CITY OF CARMEL-BY-THE-SEA HISTORIC RESOURCES BOARD

REGULAR MEETING Monday, June 19, 2023

SUBMITTED BY: Evan Kort, Associate Planner

SUBJECT: **DS 22-396 (Ramos):** Consideration of a Determination of Consistency with the Secretary of the Interior's Standards for Design Study application, DS 22-396 (Ramos), for site additions, alterations, and site modifications, including a 138-square-foot addition to the rear and a new entry at the north elevation, a 398-square-foot basement expansion, creation of a window well at the front elevation, window relocation and modifications, and a new 231-square-foot detached garage located in the front to the historic "Rockwell House" located on the northeast corner of 12th and San Antonio Avenues in the Single-Family Residential (R-1) Zoning District and the Beach and Riparian Overlay District. APN 010-279-008

SHEET NAME:
FLOOR PLAN /
ELEVATIONS /
PROPOSED TILE
OPTION

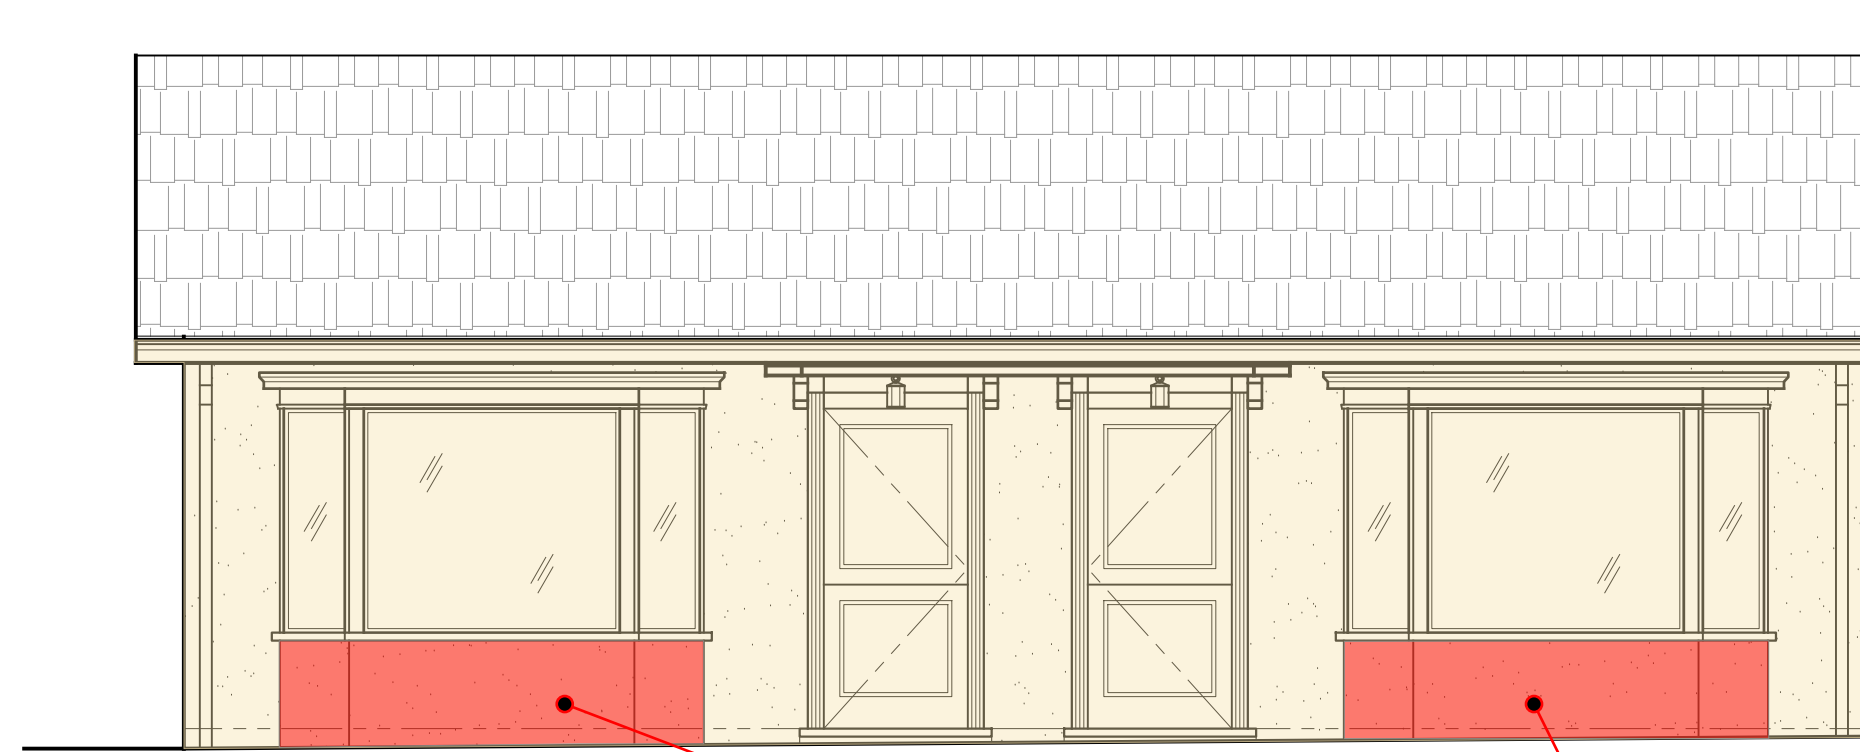
Following the completion of the painting, it was brought to staff's attention that tile had been added below the bay windows of Building #1, which would require a Design Review Application, as described above. As such, staff contacted and directed them to either remove the tile or submit an after-the-fact Design Review Application. On February 4, 2023, Design Review Application DR 23-058 was submitted (refer to Attachment 4). Review of this application required the site to be reviewed for its eligibility on the local inventory pursuant to [CMC 17.32.050.B](#), and it was found to be eligible for listing on the historic inventory as described above. Of important note, even if the site were ineligible for listing, the project would still be before the HRB for consideration pursuant to [CMC 17.20.280.B](#) due to the project's location within the Downtown Conservation District, however, it would be evaluated under different criteria.

(E) SOUTH ELEVATION
SCALE: 1/4" = 1'-0"

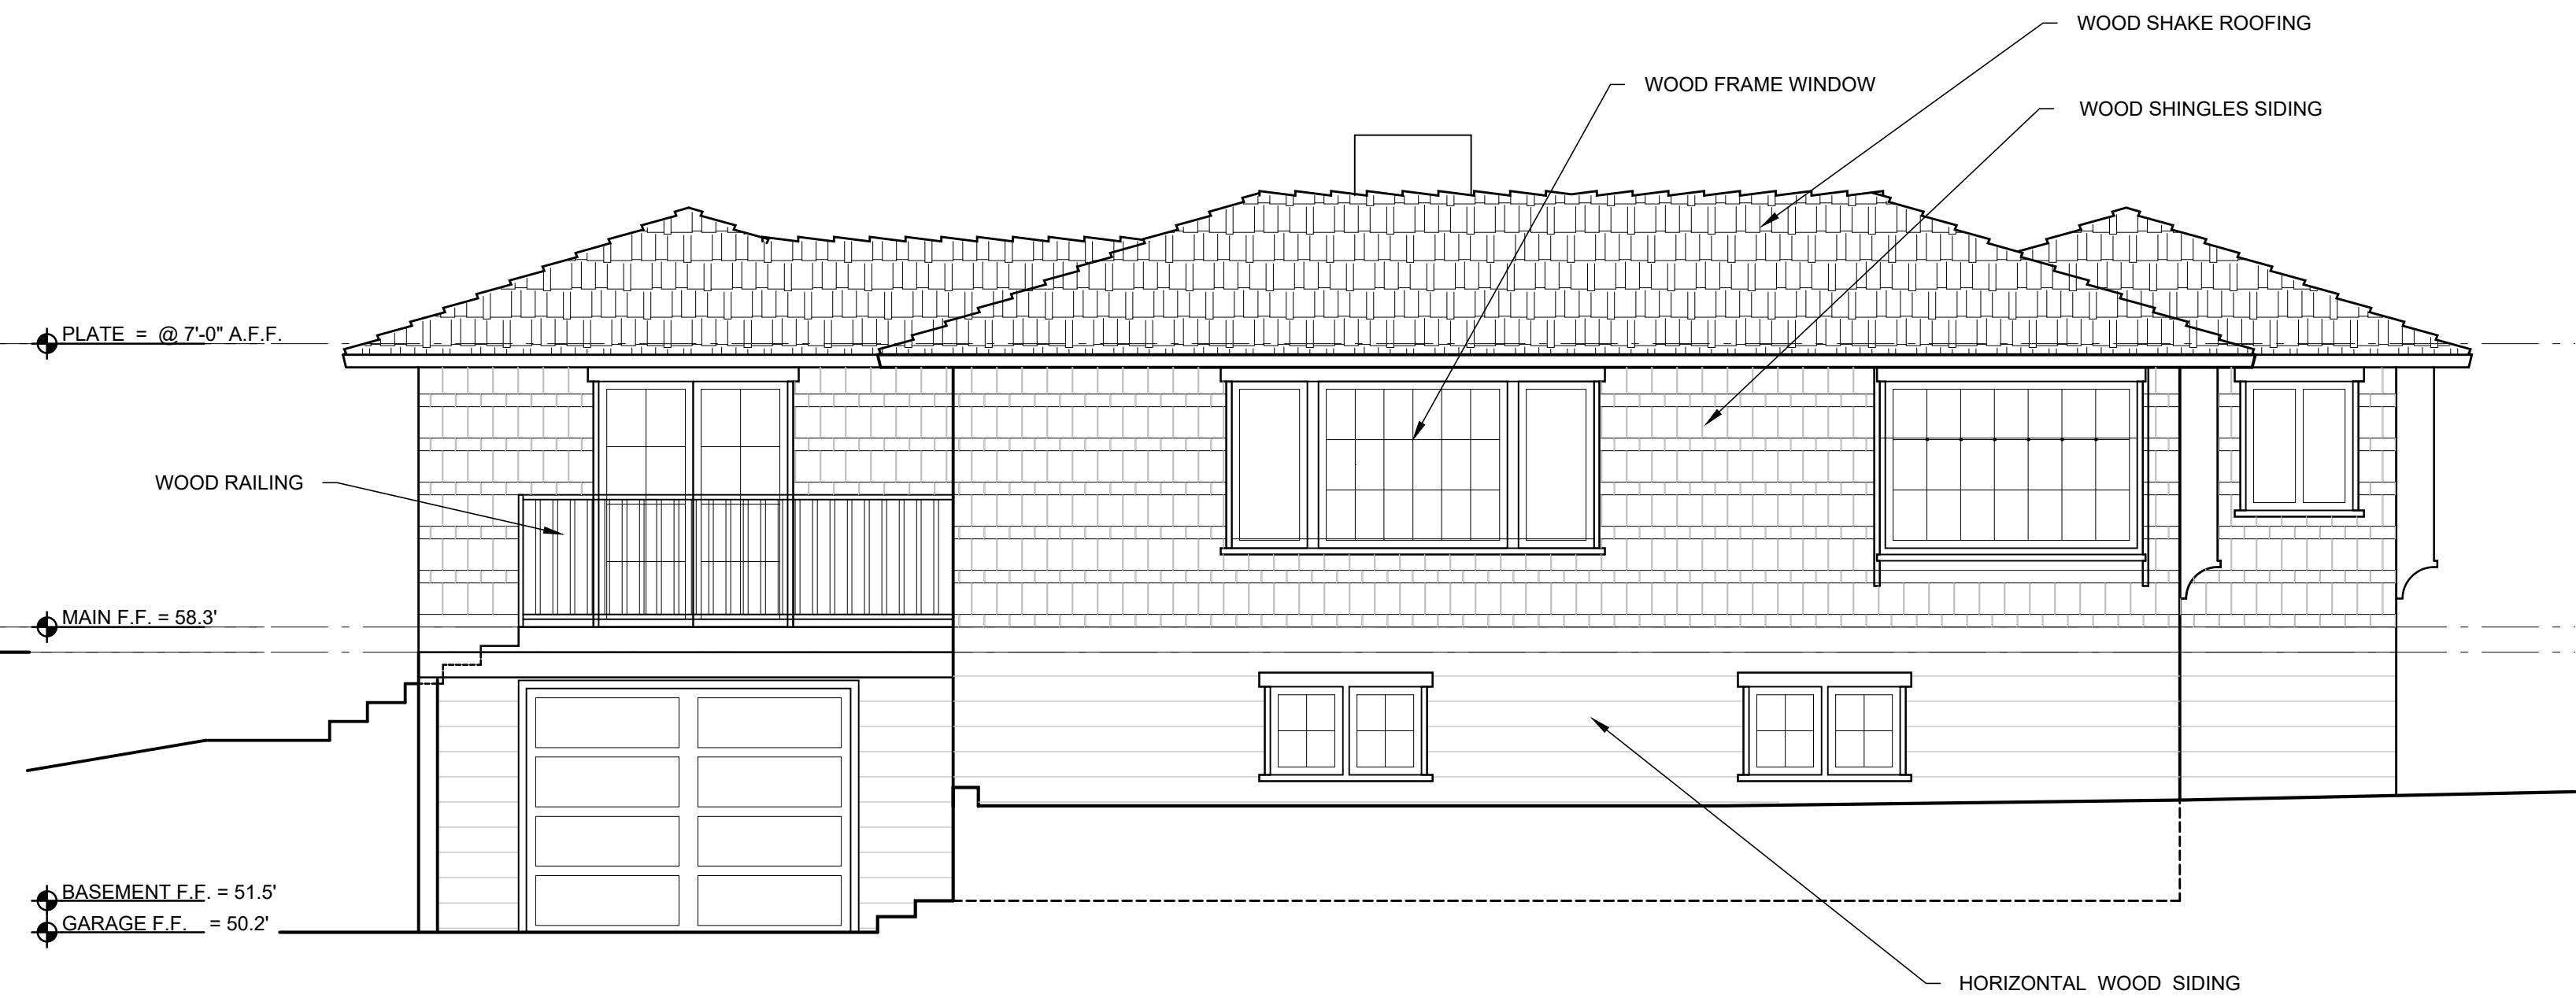
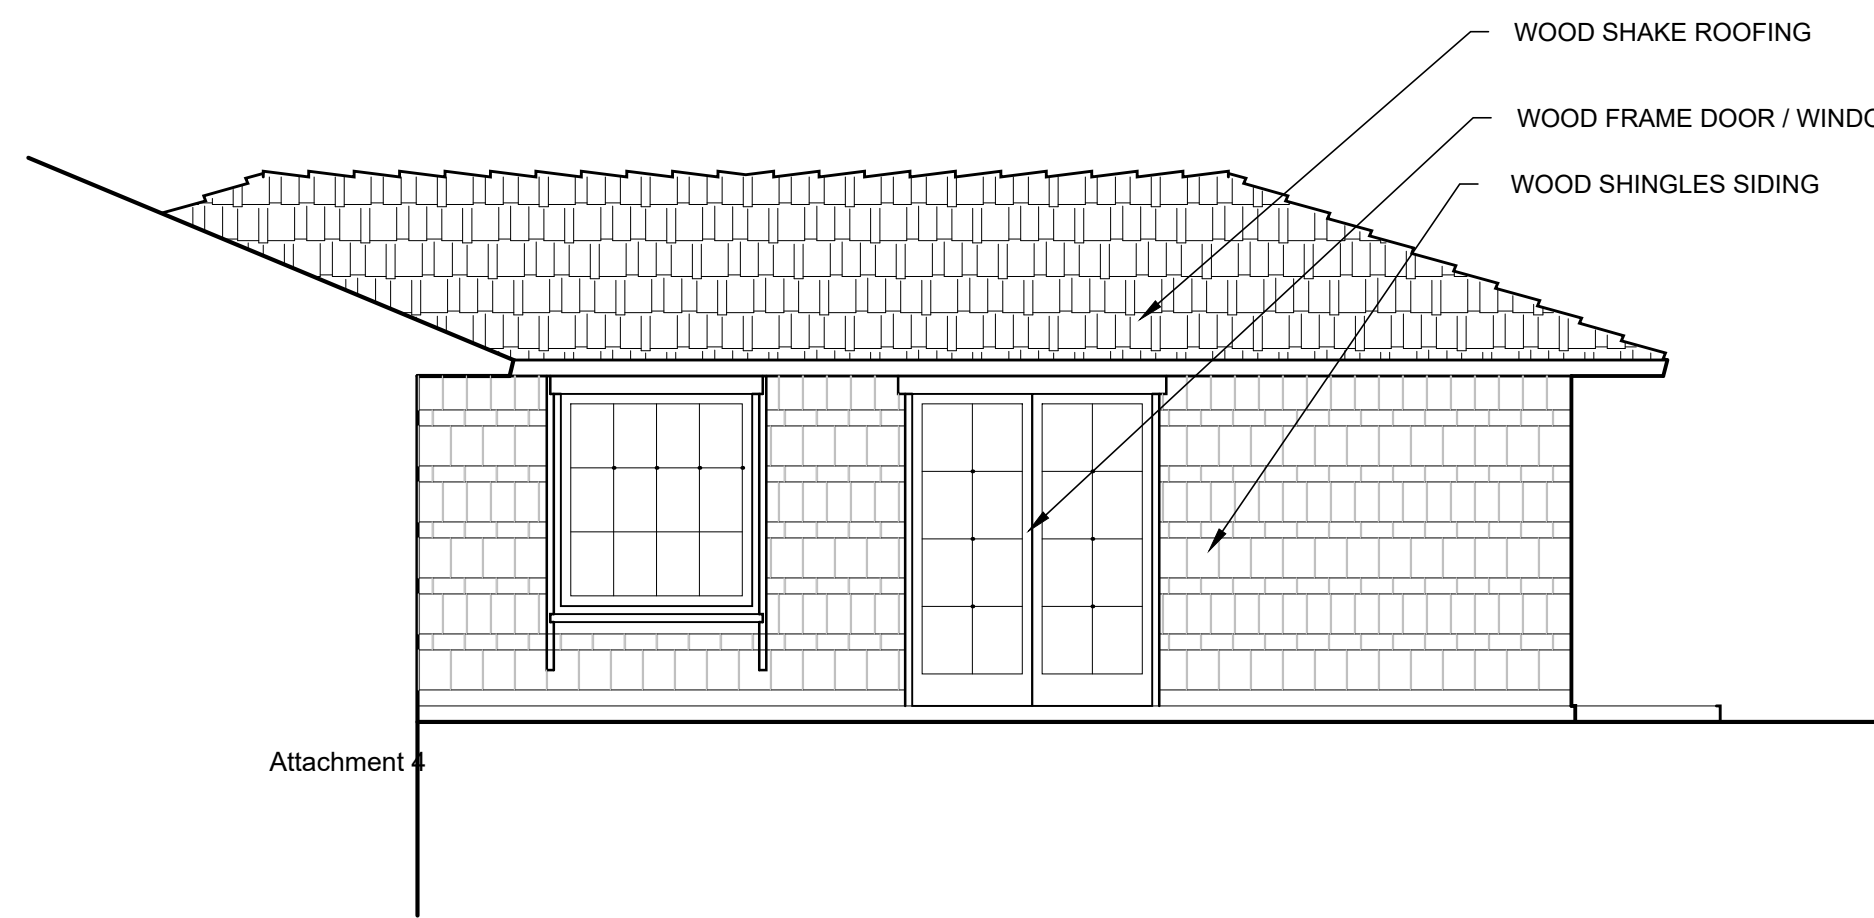
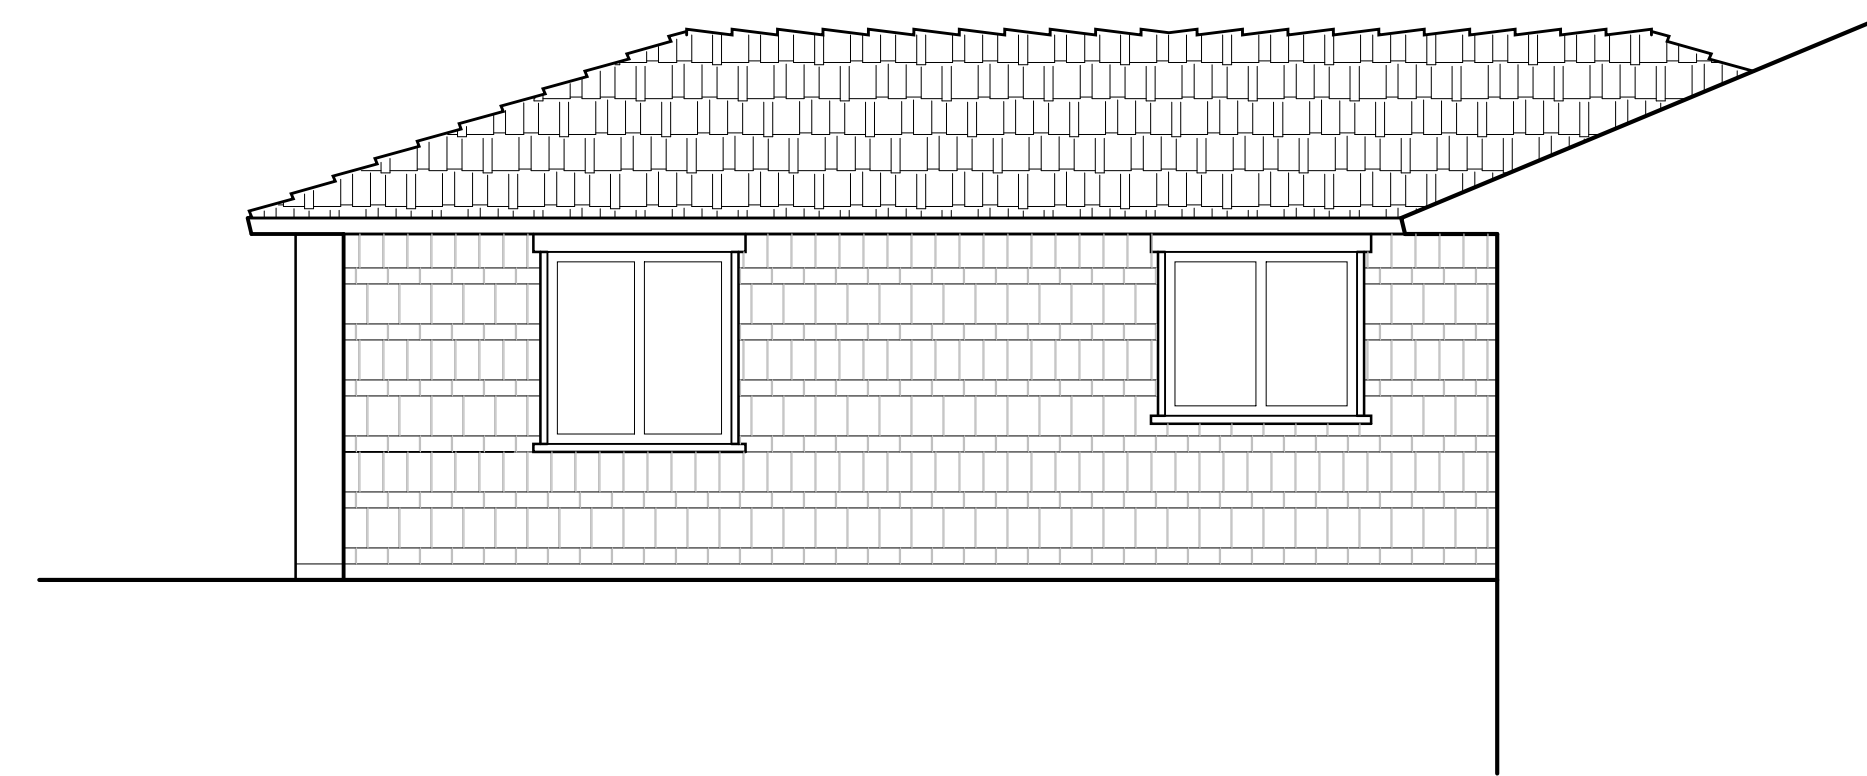
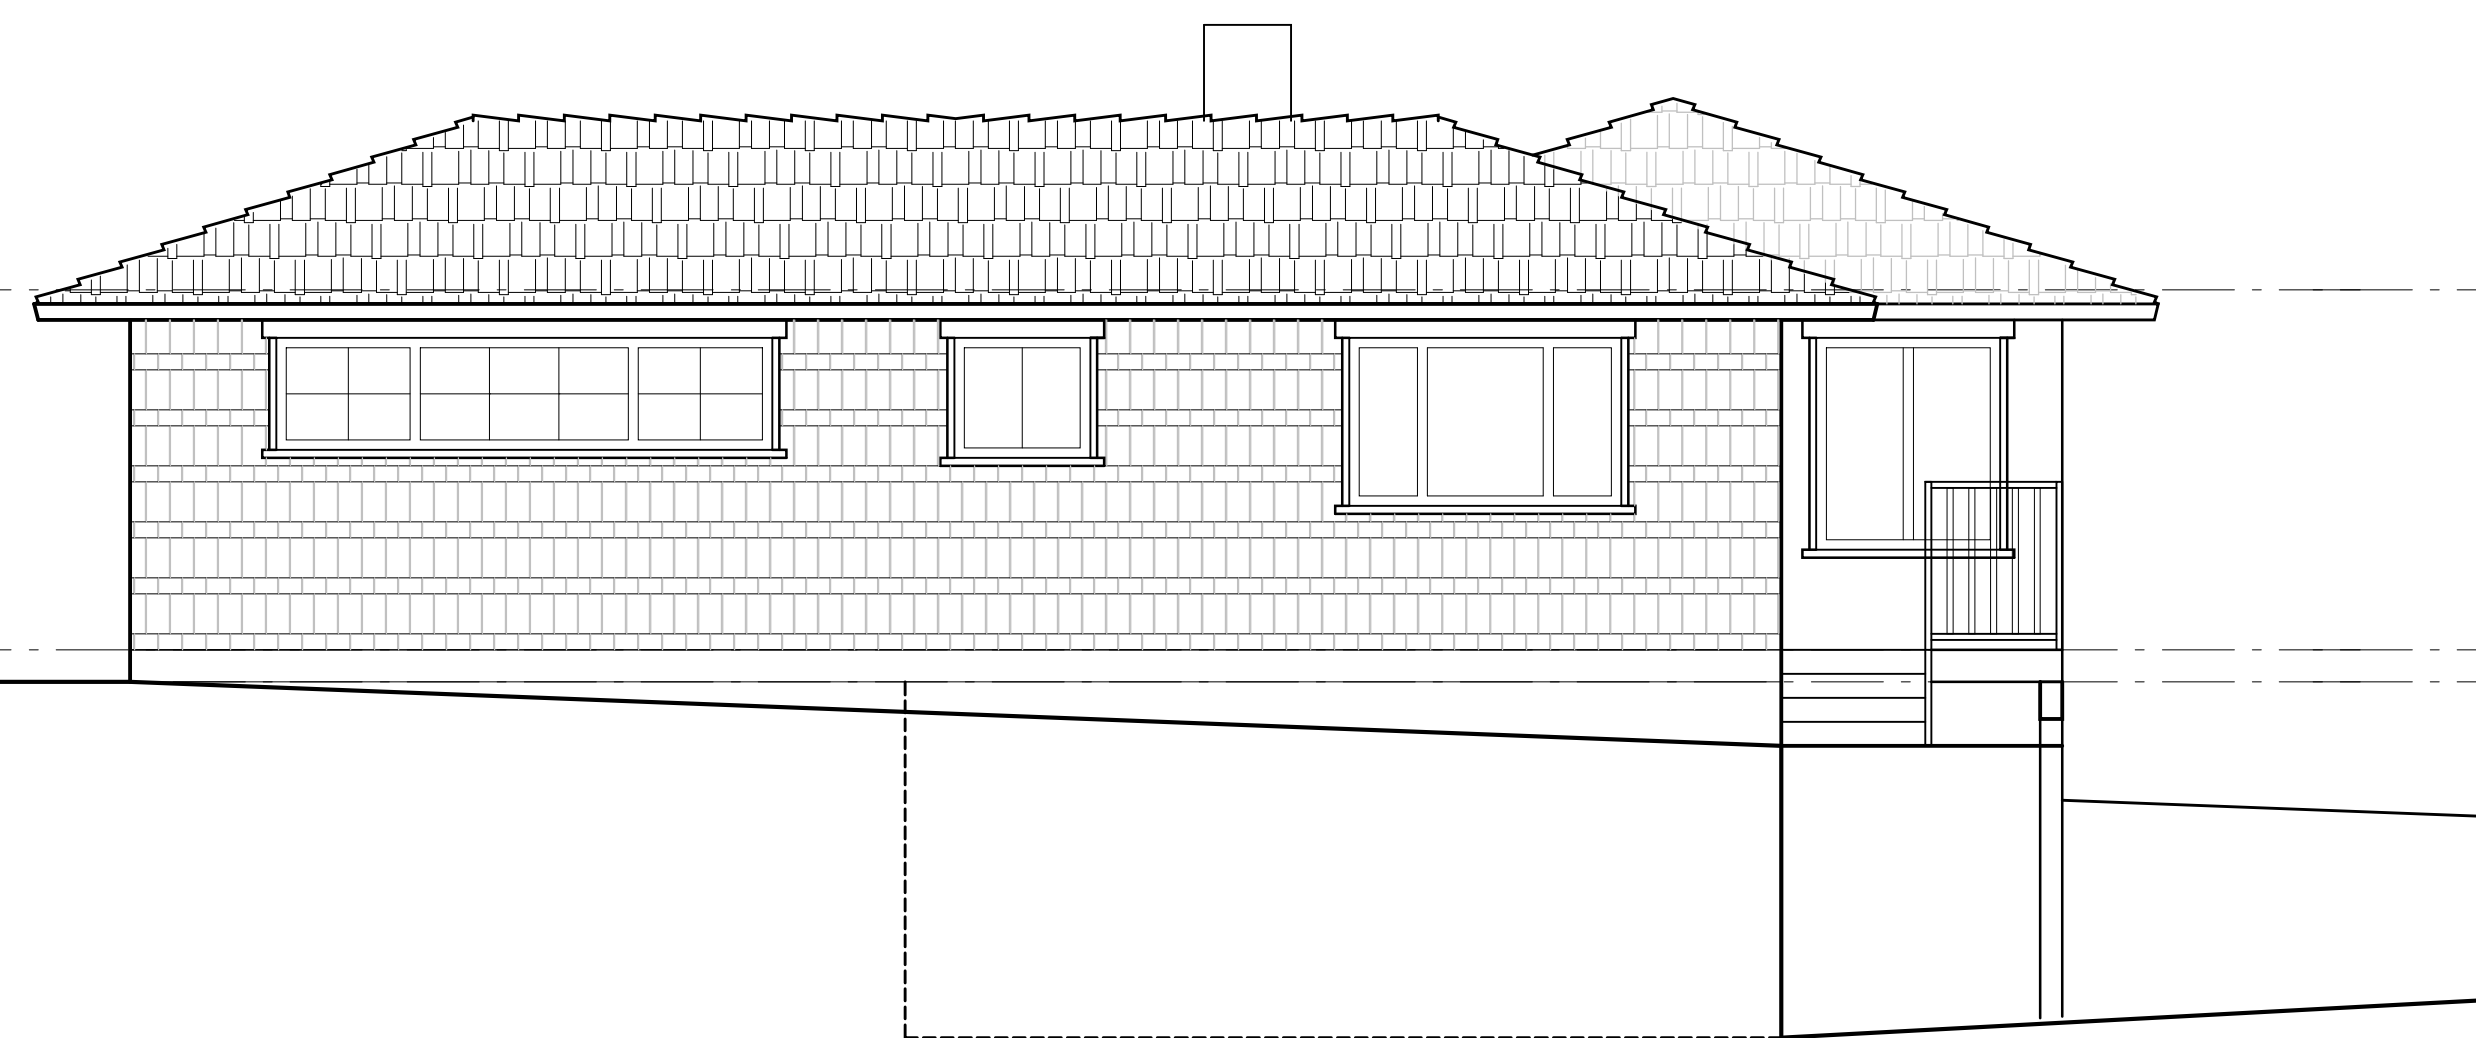
West (Front) elevation: The wood shingle siding, wood shake roofing, and most of the windows on the main level will be retained. The two small windows at the lower level will be removed. The new windows at the lower level will be screened by a window well, and a new French door will replace the garage door, which is a non-character-defining feature. However, the French door will not be visible from the street as the new detached garage will be located in front.

South (Side Street) elevation: The construction of a new entrance on the south elevation will remove one original square bay window and one non-original canted bay window. However, a relocated window will replace the non-original canted bay window. According to Meg Clovis, qualified professional, the removal of the original square bay window is not ideal, but will not affect the integrity as a whole.

East & North elevation (Rear & Side): The rear (east) addition will remove an original Dutch door and two non-original windows, and on the side (north) will remove two windows. The current kitchen area was expanded in 1950, and removing these windows does not affect the house's integrity since they are not original. However, the original Dutch door was moved to the back during the 1950 floor area expansion. The Dutch door is considered a character-defining feature and should be preserved. The applicant has proposed to reuse the Dutch door as an exterior egress door on the lower level adjacent to the proposed garage location.

2. New siding & roof materials shall be slightly differentiated but compatible with the old siding & roof materials.
3. **South elevation** - Prior to the approval of the Design Study, the applicant shall show and provide samples that the proposed entrance shall have a different aesthetics regarding the siding, roof, and columns to differentiate it from the original house.

4. **Dutch door** - Prior to the approval of the Design Study, the applicant shall repair the original Dutch door currently in the east elevation and reuse it, and, if repair is not possible, provide photos and written documents showing that the original Dutch door cannot be preserved and provide material, dimensions, and a color sample of the original prior to in-kind replacement.
